**SUBJECT:** **NEW VEHICLE DELIVERY HOLD**  
**Safety Recall 19S03 – Supplement #3**  
 Certain 2017 - 2019 Model Year Continental  
 Door Latch Replacement

- *Parts are now on open order for the Power Door Cinch Kit GD9Z-54264A26-CA*  
*NOTE: Dealers will still need to contact the SSSC to order the Non-Power Door Cinch Kit GD9Z-54264A26-BA*
- *Updated Technical Information for installing the driver door latch*
- *Updated Lincoln Client Special Handling Information specific to this recall*

## CERTAIN 2017 – 2019 MODEL YEAR CONTINENTAL VEHICLES — DOOR LATCH REPLACEMENT

**FIGURE 1**

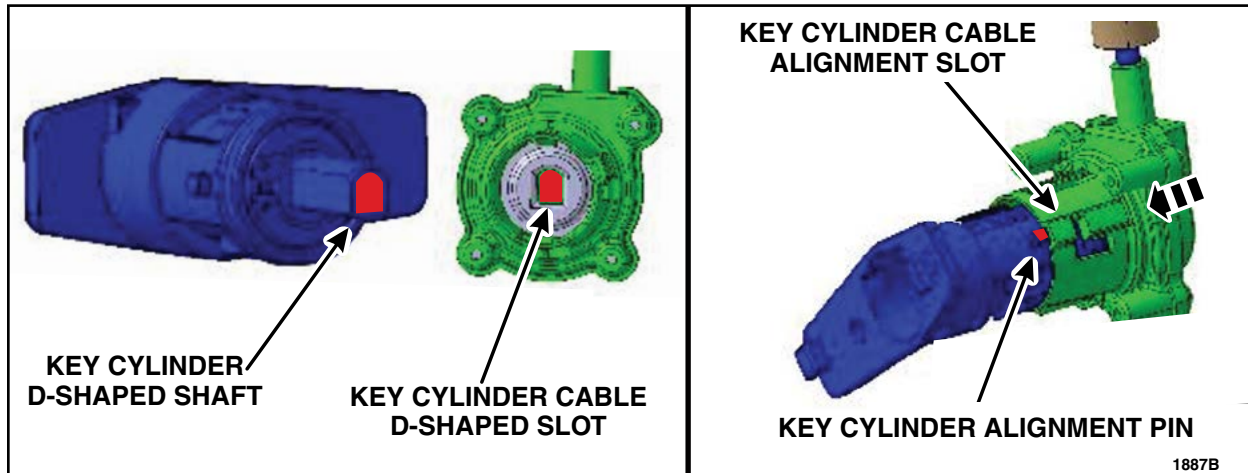
**NOTE:** *On the driver front door ONLY, refer to Steps 2-5 when installing the door latch, to ensure proper operation of the key cylinder and latch assembly.*

1. Replace the driver and passenger front door latches. Please follow the Workshop Manual (WSM) procedures in Section 501-14.
2. *The D-Shaped key cylinder shaft must align with the side door key cylinder cables D-Shaped slot and align the key cylinder pin with the key cylinder cable slot. See Figure 1.*

**FIGURE 2**

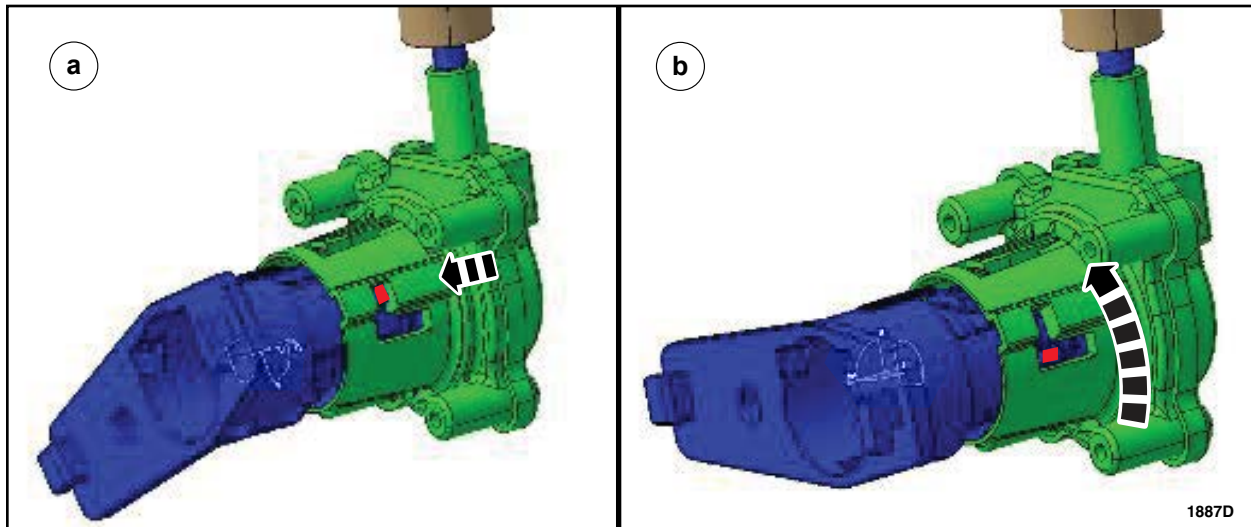
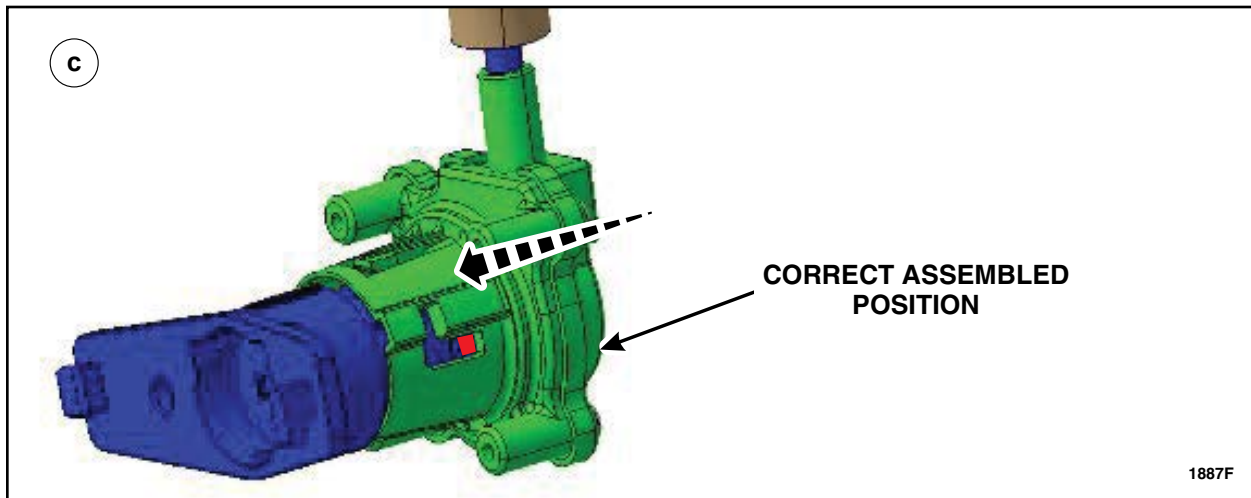
3. Install the key cylinder cable onto the key cylinder. See Figures 1,2 and 3.

- a. With the key cylinder cable slot aligned with the key cylinder pin push the cable on until it stops.
- b. Rotate the cable end until it stops.
- c. Push the cable onto the key cylinder until it stops.

**FIGURE 4**

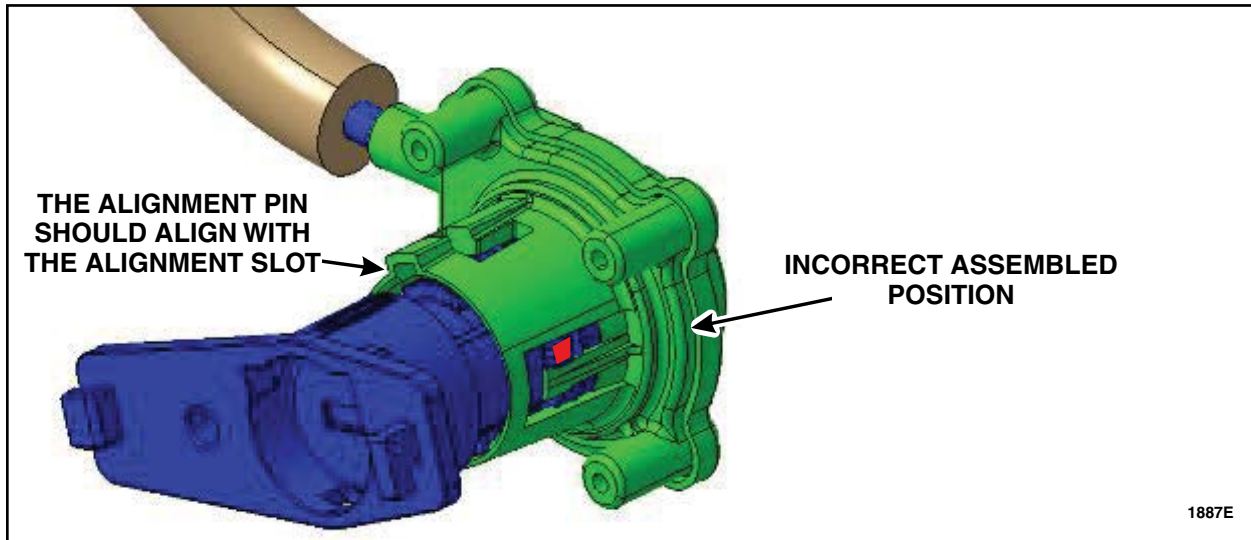
**NOTE:** Figure 4 shows an incorrectly assembled key cylinder and cable assembly for reference.

4. Ensure that the key cylinder cable slot is aligned with the key cylinder pin. Figure 4 shows an incorrect assembled key cylinder and cable assembly.

**FIGURE 5**

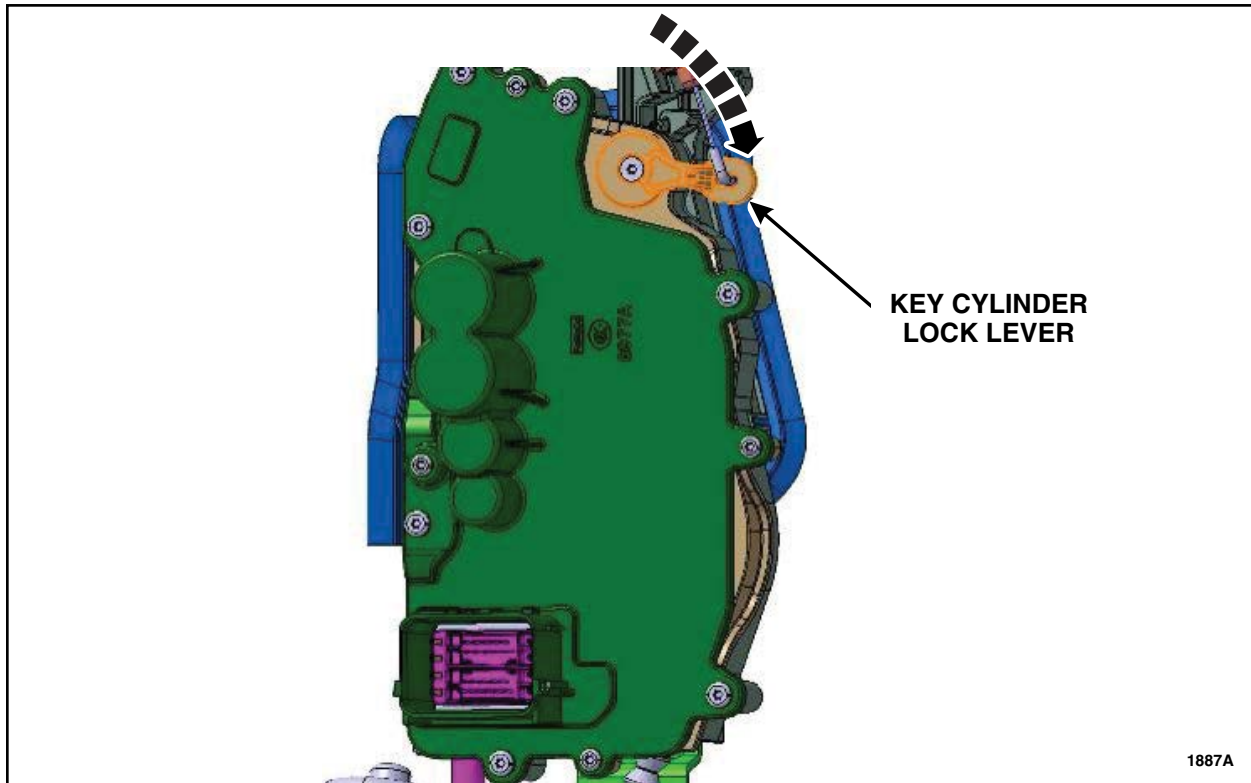
5. After the installation of the driver door E-Latch assembly, ensure that the key cylinder lock cable lever is in the downward position before installing the door trim panel. See Figure 5.
